#### Final Data Quality Objectives Report for the RVAAP-34 Sand Creek Disposal Road Landfill Version 1.0

Ravenna Army Ammunition Plant 8451 St. Route 5 Ravenna, Ohio 44266-9297

# <u>Appendix A</u> Comment Response Table

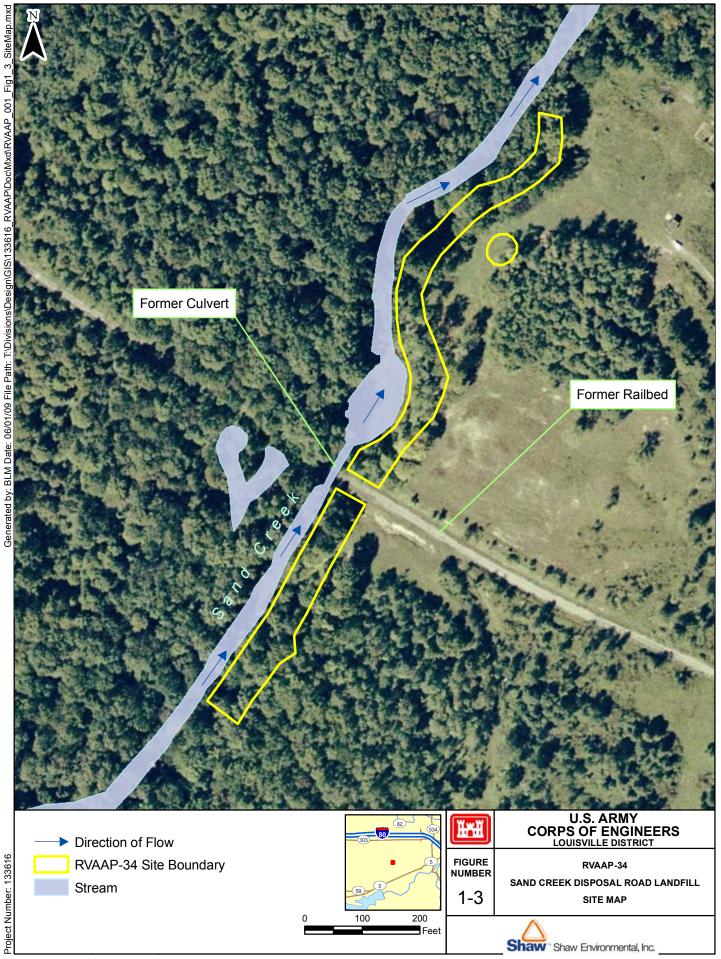
O-11	Page 2-3, line 10		The text references figure 1-3 that depicts the Sand Creek Dump boundary.	See comment #7.	See response to Comment O-7.
0-12	Page 2-4/ Line 18		Text revision requested.	Change text to read: " SLERA must be pre-approved by USACE and Ohio EPA." Delete the rest of the sentence.	Lines 17-20 will be revised to state: "Ecological screening values or benchmarks used in the SLERA must be pre-approved by USACE and the Ohio EPA."
O-13	Page 2-5/ lines 3-5		Clarification re: MEC issues.	In any areas of potential MEC, would these really represent areas that would have additional surface or sub-surface sampling? Or are you doing this for MEC avoidance?	Shaw will not perform sampling in the area where suspect MEC is identified as part of the geophysical investigation. Lines 3-5 will be revised to state: "Suspected and identified source areas of debris and residual contamination in surface soils, as presented in Section 3.0, represent specific focus areas for additional surface and subsurface sampling. The location of any suspected MEC will be marked using GPS and no intrusive activities will be performed at that location under this IRP

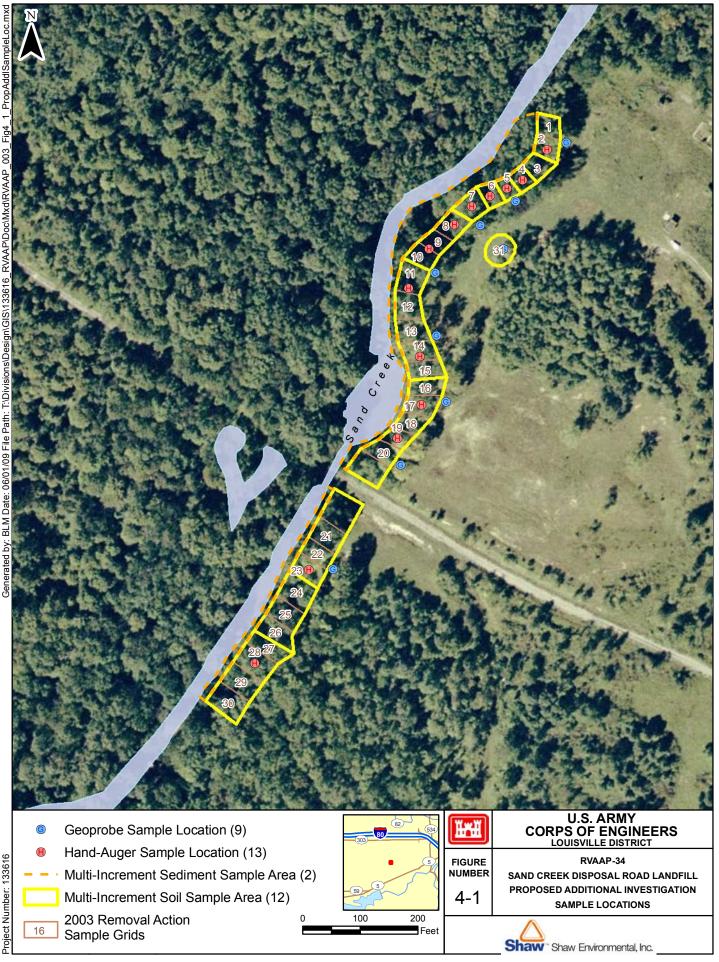
Comment Number	Page or Sheet	New Page or Sheet	Comment	Recommendation	Response
				area that are depicted on this figure. Why the distance of the boundary from the former RR tracks? Has it been determined definitively that no waste is present?	
O-37	Figure 4-1		The figure depicts only one sediment MI sample for the entire reach of the stream.	This needs to be discussed. One sample is not adequate. Minimally I would recommend dividing the area in half. (I could also re-confirm with our Division of Surface Water as to reach distances that are traditionally sampled.)	As agreed upon by Ohio EPA during the 5/26/09 conference call, Shaw will split the proposed sediment sample coverage area in two; one north and one south of the former rail road tracks, respectively.
O-38	Page 4-5/ lines 33-36		Only 1 MI sample over the entire reach of Sand Creek adjacent to the dump is proposed.	This needs to be discussed. Justify why one sample would be considered adequate. Minimally I would recommend dividing the area in half. (I could also re-confirm with our Division of Surface Water as to reach distances that are traditionally sampled.)	See response to Comment O-37.

O-39	Page 5-2/ line 9		Only 1 MI sample over the entire reach of Sand Creek adjacent to the dump is proposed.	This needs to be discussed. Justify why one sample would be considered adequate. Minimally I would recommend dividing the area in half. (I could also re-confirm with our Division of Surface Water as to reach distances that are traditionally sampled.)	See response to Comment O-37.
